CITY PLANNING COMMISSION

- APPLICATION:**
- A. Negative Declaration
 - B. Rezone from Townhouse (R-1A) to Single Family (R-1) (Sec. 13)
 - C. Tentative Map (P85-139)
 - D. Subdivision Modification to create lots in excess of 160 feet deep (Ch. 40.322(c))
 - E. Subdivision Modification to create reverse frontage lots (Ch. 40.326)

PROPOSAL: The applicant is requesting the necessary entitlements to subdivide 48+ vacant acres into 223 single family residential lots.

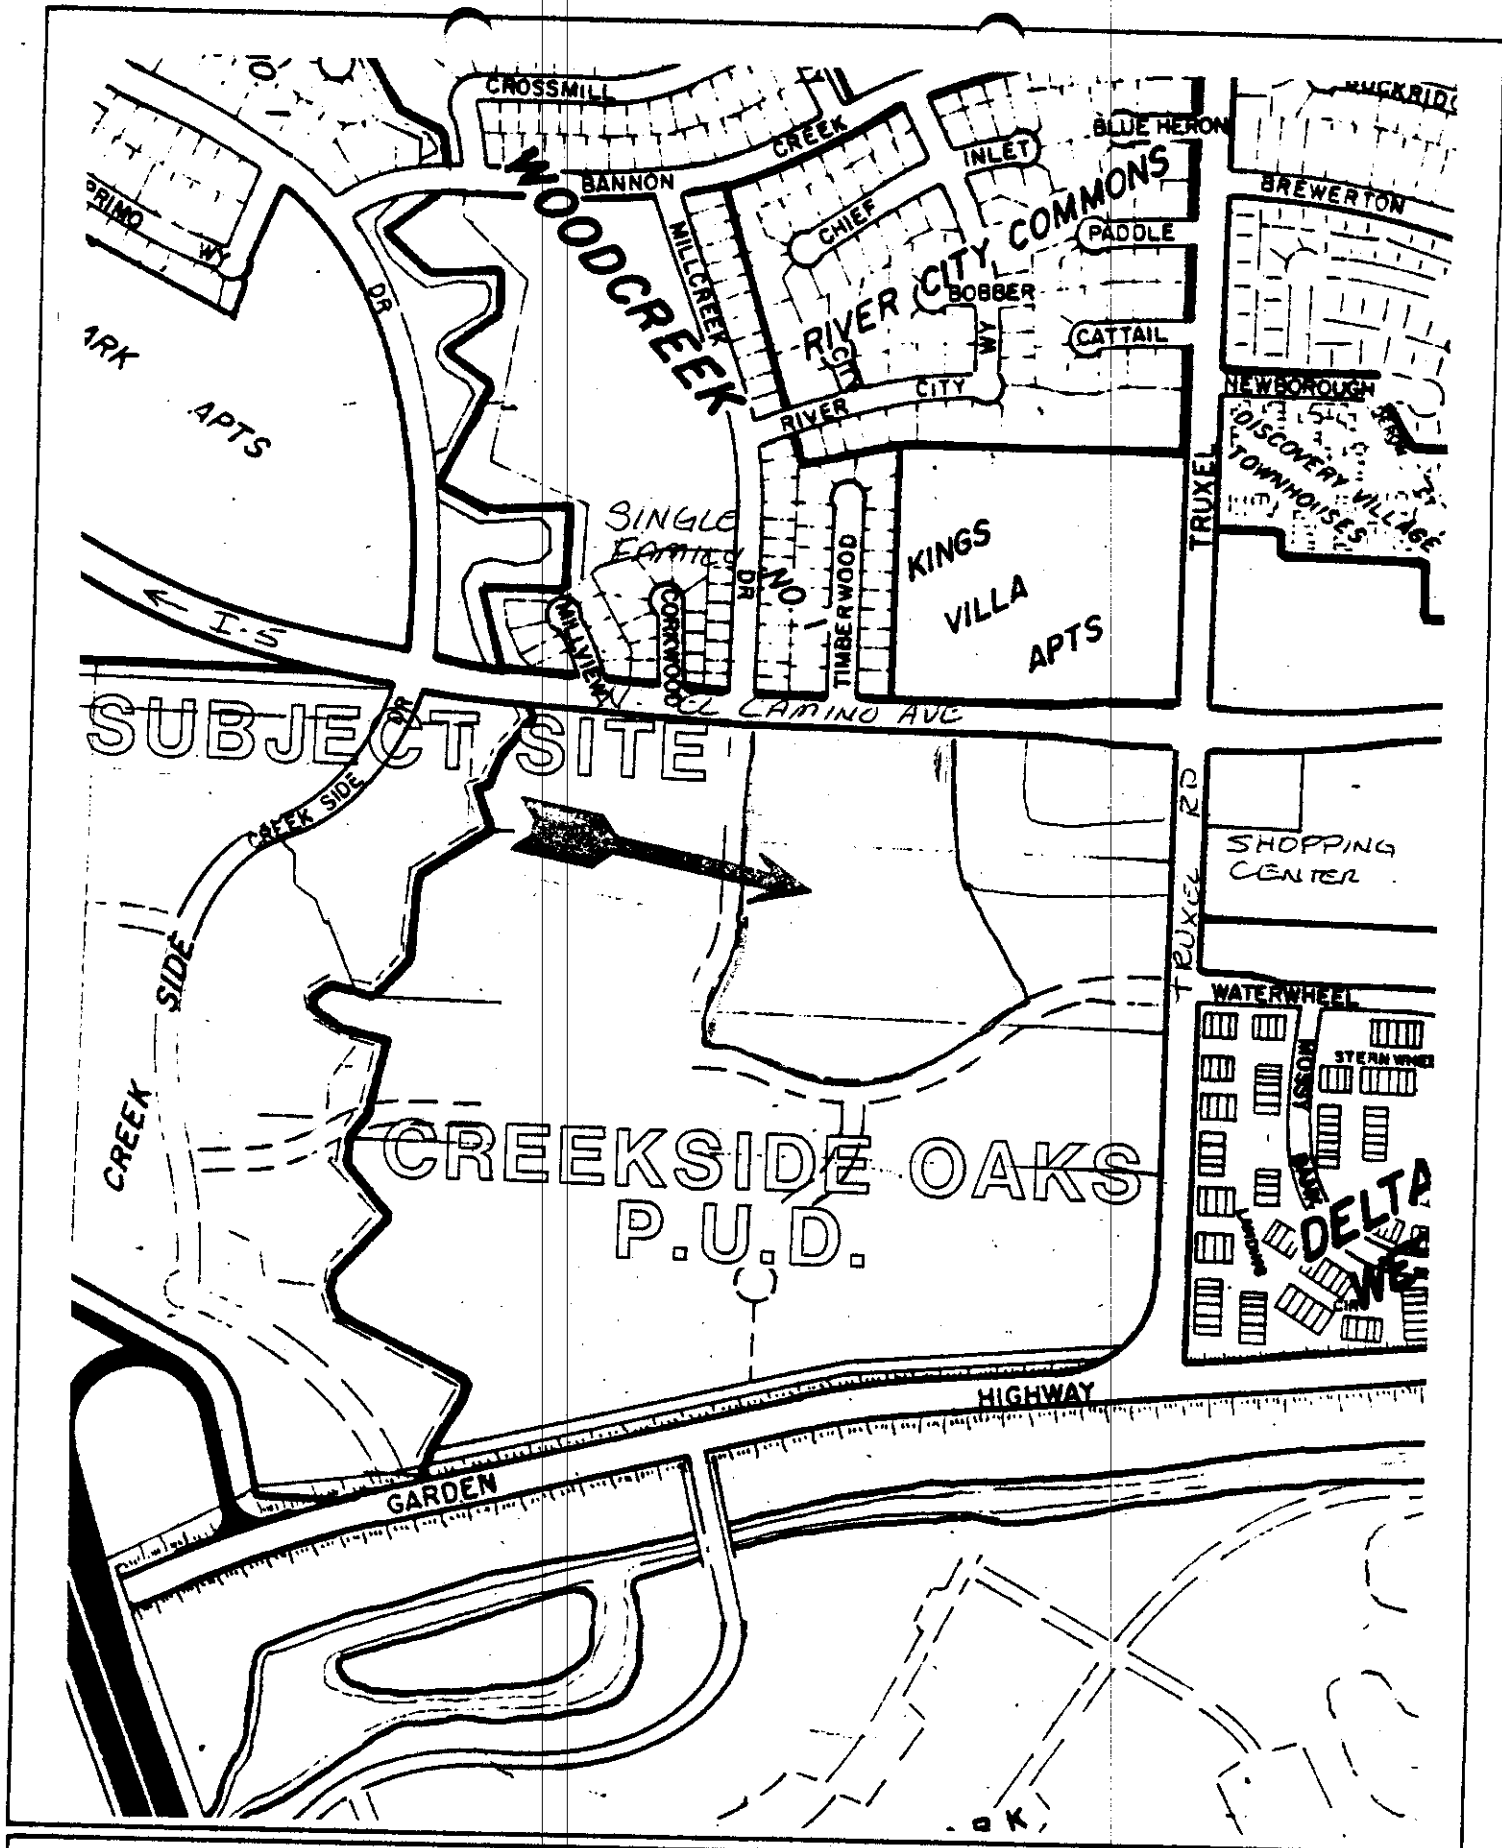
- C. Design: Staff's primary concern with this request is in regard to the seven lots which back onto Meadowview Road. These lots will require buffering for noise and privacy which generally translates into a wall. Staff would not ordinarily support the necessary subdivision modification to create reverse frontage lots. The applicant has pointed out the following design constraints peculiar to the subject site which have caused staff to support this request:

1. There is an existing 10-foot wide drainage easement trending north/south at approximately the center of the site. Utility easements are best located in the center of a street or the rear of a lot. This dictates the location of Branchwood Way;
2. The alignment of G Parkway is dictated by the need for street frontage along park sites and the location of Western Pacific Railroad tracks and the Brookfield/Meadowview intersection;
3. The grade separation between Meadowview Road and the subject site (approx. 4 feet);
4. The Traffic Engineer prefers the reverse frontage lot alternative because people tend to want to pull directly into their driveway from the street.

This design minimizes the number of lots adjacent to the railroad tracks. Financial institutions consider this point important when processing loan packages.

- D. Lots 7 and 71 have side lot lines which exceed 160 feet in depth. Staff supports this subdivision modification request due to the irregular shape of the subject site. These lots should be restricted to single family uses.
- E. The previous approval was conditioned that the applicant construct a sound wall to mitigate noise impacts generated by the railroad tracks. Should a wall be required, a decorative design should be approved by the Planning Director. In addition, the same design and materials of the wall should extend around the seven reverse frontage lots on Meadowview Road. A metal wall will not be acceptable.
- F. The triangular property at the intersection of Meadowview and Brookfield is not owned by the applicant. A proposed future lotting pattern indicates this site can be developed with residential uses (2 lots).

- A. Ratification of the Negative Declaration;
- B. Approval of the Rezoning from Townhouse (R-1A) to Single Family (R-1);
- C. Approval of the Tentative Map, subject to conditions which follow;
- D. Approval of the Subdivision Modification to create lots in excess of 160 feet deep;
- E. Approval of the Subdivision Modification to create reverse frontage lots.

15. The design of a decorative sound wall shall be subject to review and approval of the Planning Director. Said wall shall be continued behind lots 84-90.

16. The following note shall be placed on the final map: Lots 7 and 71 are restricted to single family development.
